Yorkshire Green Energy Enablement (GREEN) Project

**Document 8.4.2 Applicant's Response to OFH1 and ISH1 Hearing
Action Points**

**Final Issue A
April 2023**

Planning Inspectorate Reference: EN020024

Table 2.1 – Activities during construction phasing

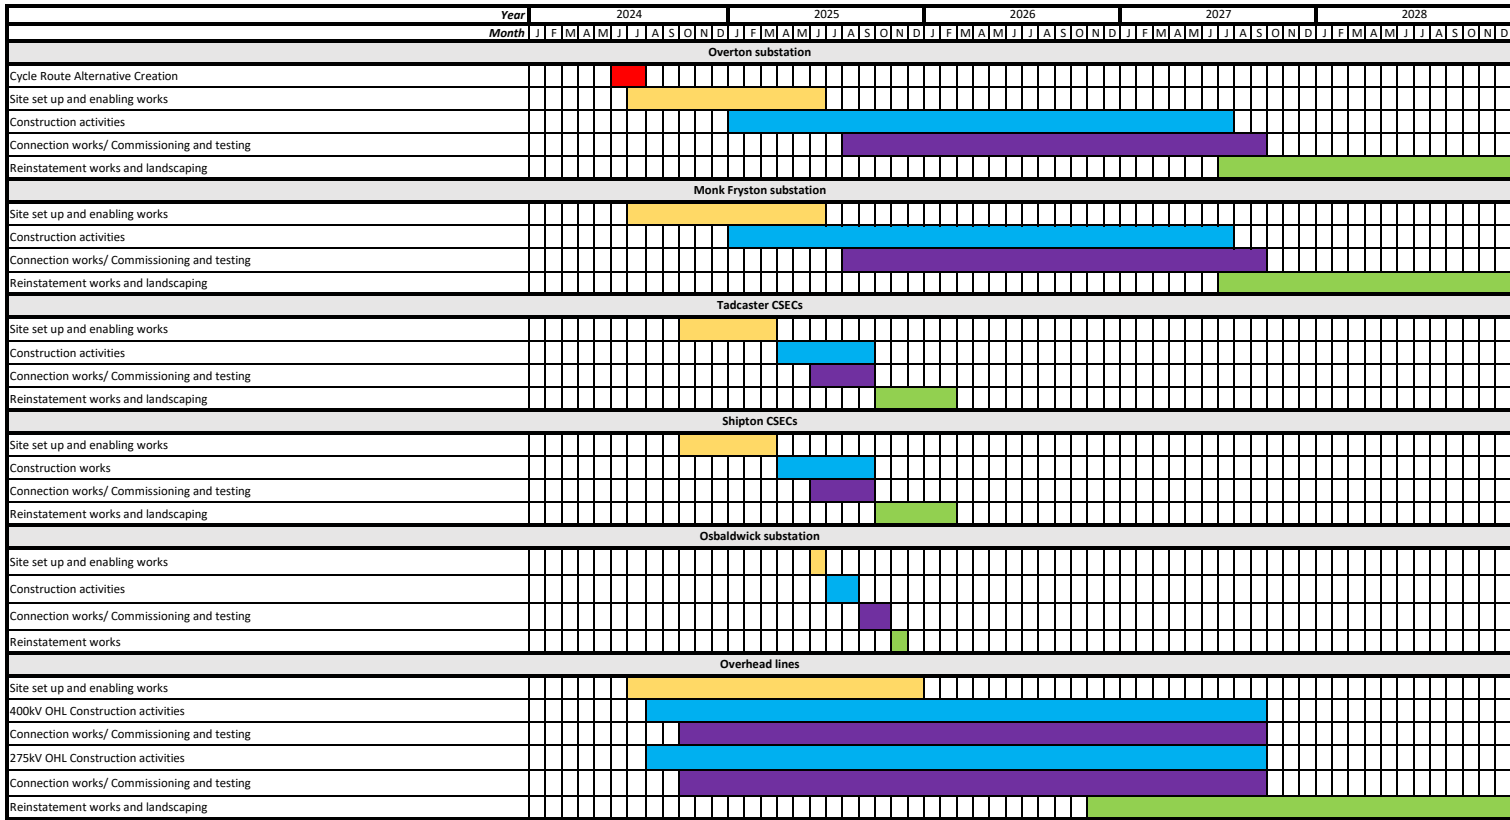
- 1.1.1 Action 6 of the Issue Specific Hearing 1 was to “*provide a post hearing note to update the indicative construction programme and the Gantt charts to cover the queries raised to align with each other.*”

- 2.1.1 The Indicative Construction Programme (provided as **Table 3.2 of ES Chapter 3: Description of the Project (Document 5.2.3, [APP-075])**) has been updated to include a new phase for Overton Substation (Cycle Route Alternative Creation) and for advanced planting at Monk Fryston and Overton Substations and is provided in Appendix A to this note. It should be noted that works in respect of permanent earth landscaping mounds are identified as construction activity (blue in key).

- 2.1.2 Table 2.1 below provides further clarification on the indicative construction phases, including the additional phases added into the Indicative Construction Programme to further clarify the phases of construction assessed in the ES, and describes the type of activities which would take place during these phases, including a key to the construction programme. This should be read in conjunction with the updated Indicative Construction Programme provided in Appendix A to this note.
